Reactor Oversight Process Whitepaper – Modification of the Description of Unplanned Scrams with Complications Performance Indicator to Reflect AP1000 Design

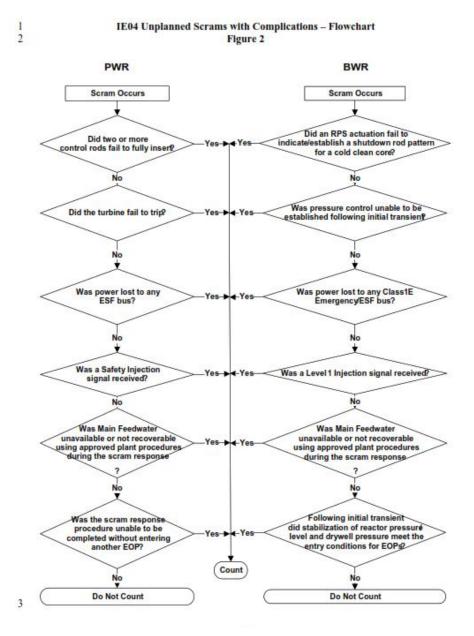
- 1. The current screening question for control rods failing to fully insert (NEI 99-02, Rev. 7, page 22, line 34) should be modified to add a remark qualifying AP1000 applicable control rods:
 - Did two or more control rods fail to fully insert? (For AP1000 plants: Consider Rod Cluster Control Assembly (RCCAs) Only)

- 2. The current screening question about "Was Main Feedwater unavailable or not recoverable using approved plant procedures during the scram response?" (NEI 99-02, Rev. 7, page 24, line 4) should be modified to add a remark defining the AP1000 equivalent of Main Feedwater as Main, Cross-Tied, and Startup Feedwater Sources:
 - Was Main Feedwater unavailable or not recoverable using approved plant procedures during the scram response? (For AP1000 plants: Were all three of the following unavailable or not recoverable using approved plant procedures during the scram response:
 - (1) Main Feedwater,
 - (2) Cross-Tied Feedwater, that is, Main Feed flow through the Startup Feed Control Valves, and

- 3. The current screening question about "Was the scram response procedure unable to be completed without entering another EOP?" (NEI 99-02, Rev. 7, page 24, line 31) should be modified to add a remark permitting common and typical AP1000 EOPs used upon a normal uncomplicated scram:
 - Was the scram response procedure unable to be completed without entering another EOP? (For AP1000 plants: Use of ES-0.1 and/or ES-0.3 through ES-0.6, and/or Yellow Path procedures, do not constitute a complicated scram.)

For AP1000 plants, EOP steps justify multiple stuck gray rods would not constitute a complicated scram: ES-0.1 Step 10 Action/Expected Response (AER) checks all RCCAs fully inserted and uses this to determine whether or not to borate per AOP-102, "Rapid Boration". However, the Gray Rod Control Assemblies (GRCAs) are not considered when determining the need to borate, because GRCAs are not considered in the Shutdown Margin (SDM) calculation while in MODE 1 as displayed on On-Line Power Distribution Monitoring System (OPDMS) (OPDMS displays Xe-free conditions with one stuck rod). Per Tech Specs, SDM in Mode 2 with Keff < 1.0, and in Modes 3,4, and 5, the worth of fully inserted gray rods may be included in the SDM calculation if verified fully inserted by two independent means. Because NEI 99-02 Rev 7 Section 2.1 pages 22-23 beginning at line 34 (PWR Flowchart Question for "Did two or more control rods fail to fully insert?") defers to the plant's EOP evaluation criteria, based on whether additional actions are required by operators, no counting of stuck GRCAs is required for this indicator. That is, for AP1000, the question would be "Did two or more Black Control Rods (RCCAs) (excluding GRCAs) fail to fully insert?"

For AP1000 plants, the safety-related, non-electric, Passive Residual Heat Removal (PRHR) Heat Exchanger functions as Emergency Feedwater. Any AP1000 available or recoverable motor-driven feedwater source protects from complicated scrams requiring safety-related passive cooling.

For AP1000 plants, EOPs ES-0.1, ES-0.3, ES-0.4, ES-0.5, and ES-0.6 are commonly used upon a normal scram, and do not constitute a scram with complications:
